Executive Director's Recommendation

Commission Meeting: May 2, 2019

PROJECT Perimeter Fence Replacement and Gate Improvements United States National Arboretum 3501 New York Avenue, NE Washington, DC	NCPC FILE NUMBER 8064
SUBMITTED BY United States Department of Agriculture National Arboretum	NCPC MAP FILE NUMBER 43.20(38.40)44910
REVIEW AUTHORITY Federal Projects in the District per 40 U.S.C. § 8722(b)(1) and (d)	APPLICANT'S REQUEST Approval of comments on concept design
	PROPOSED ACTION Approve comments as requested
	ACTION ITEM TYPE Staff Presentation

STV 100 Years
 STV Incorporated
 205 West Walsh Drive
 Douglasville, PA 19518
 Tel (810) 365-4200 / Fax (810) 365-4501
 www.stvinc.com

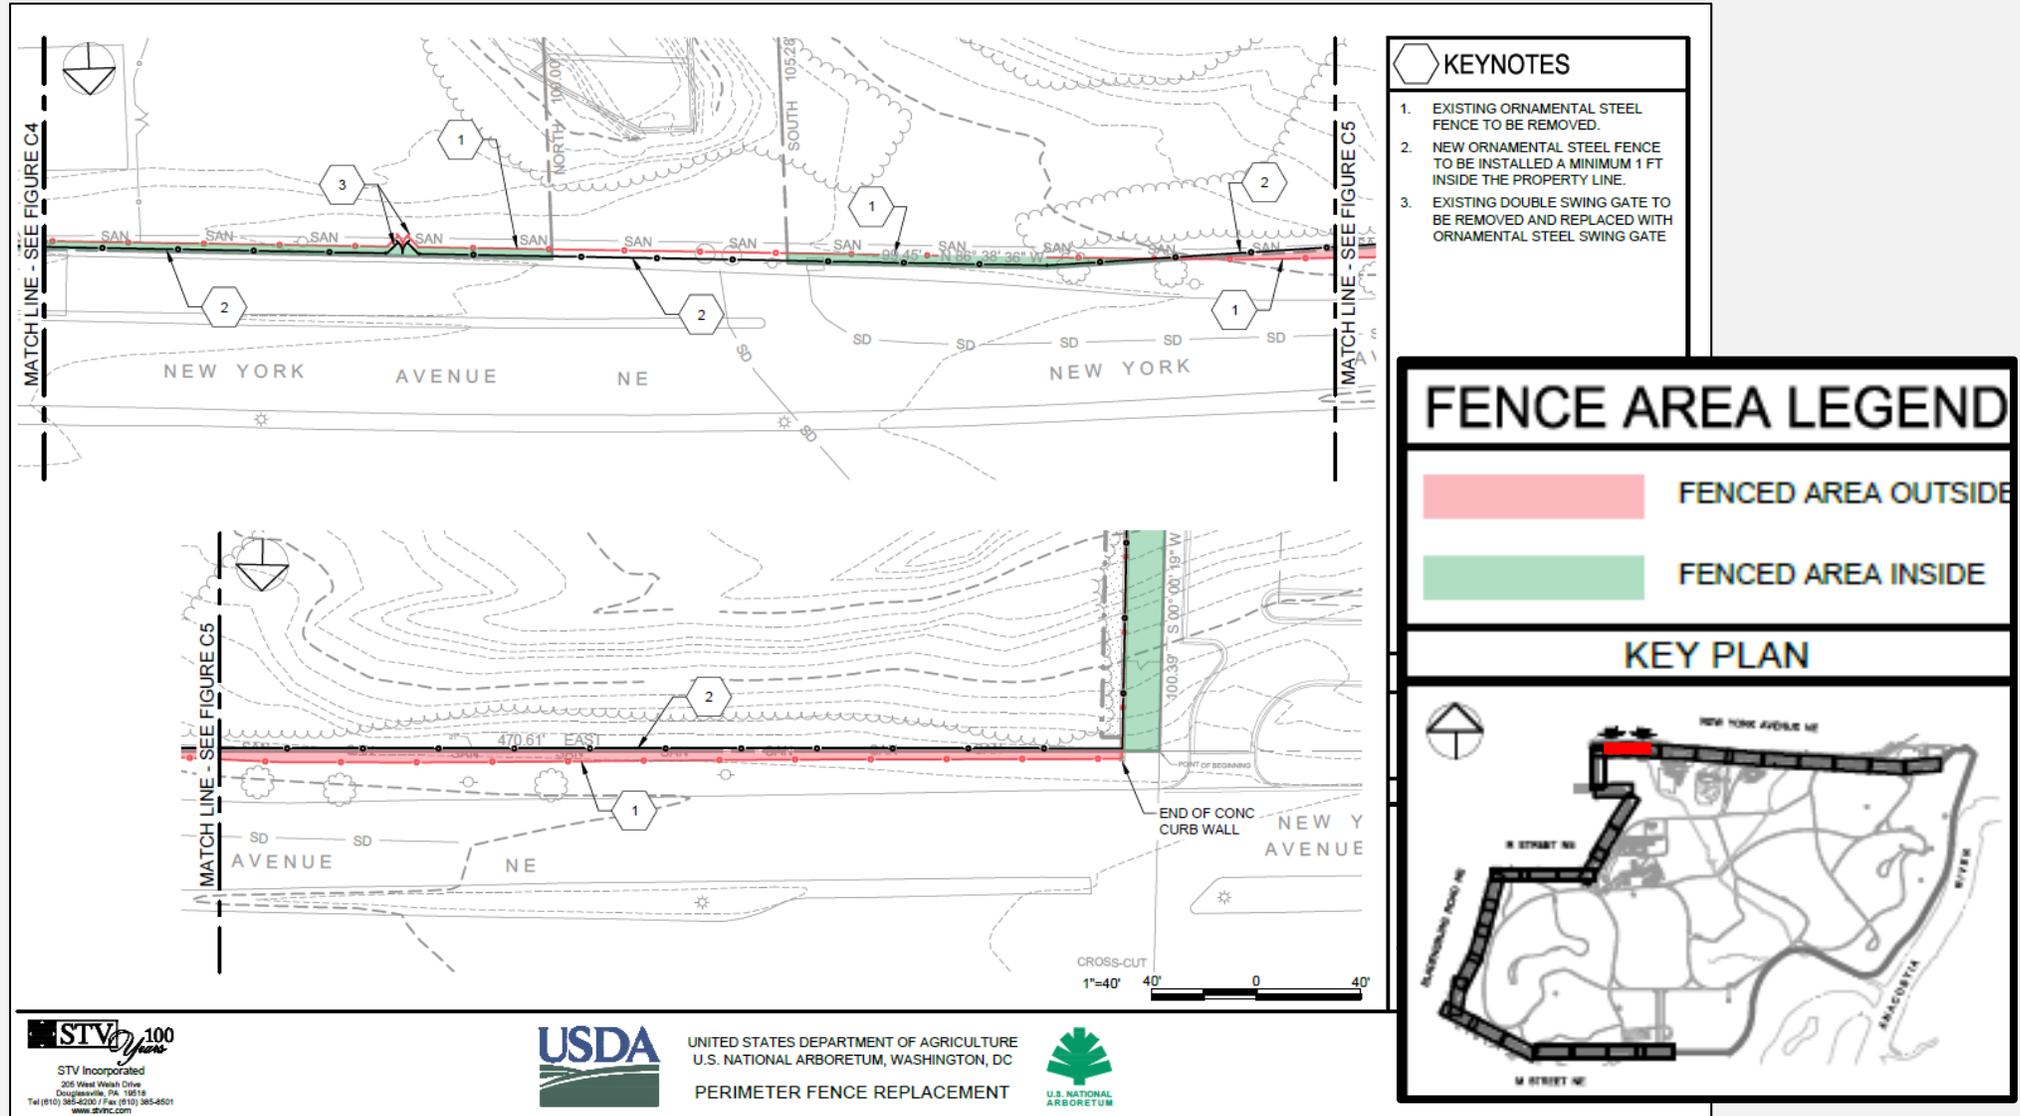
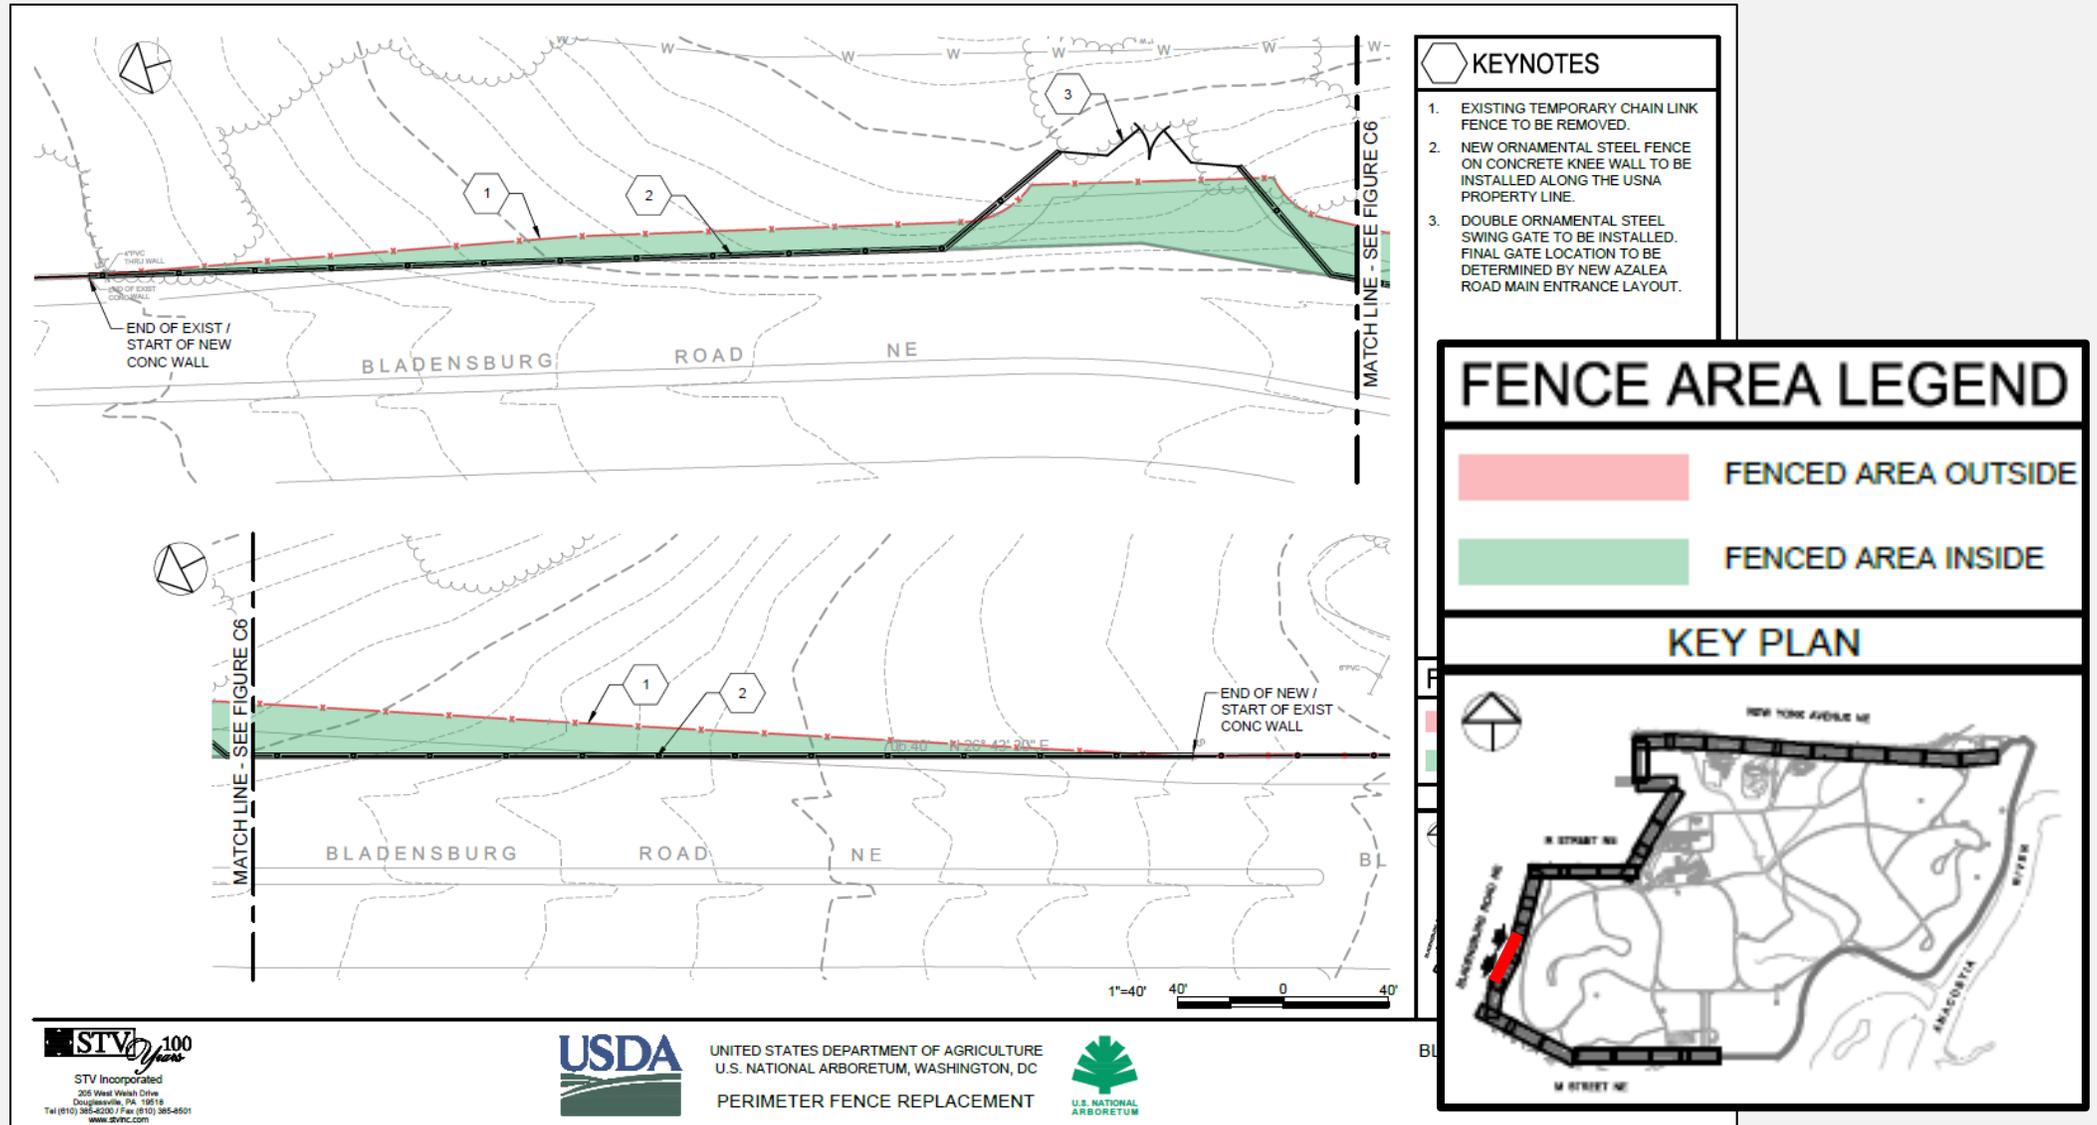
Notes that new perimeter fencing will be realigned on to federal property under the jurisdiction of the National Arboretum in four locations along the northern perimeter and one location along the western perimeter.

The USNA will replace all new perimeter fencing along the same alignment except in areas where the perimeter fence does not correctly align with the property line. Four of the locations are situated in the north along New York Avenue and a fifth fence section is located along Bladensburg Road. In these locations, the perimeter fence is either aligned several feet behind the Arboretum property line (on federal property), and in the other locations, or aligned on District right-of-way. All five new fence sections will be properly installed on federal property parallel to the property line. Therefore, staff recommends that the Commission **note that new perimeter fencing will be realigned on to federal property under the jurisdiction of the National Arboretum in four locations along the northern perimeter and one location along the western perimeter.**
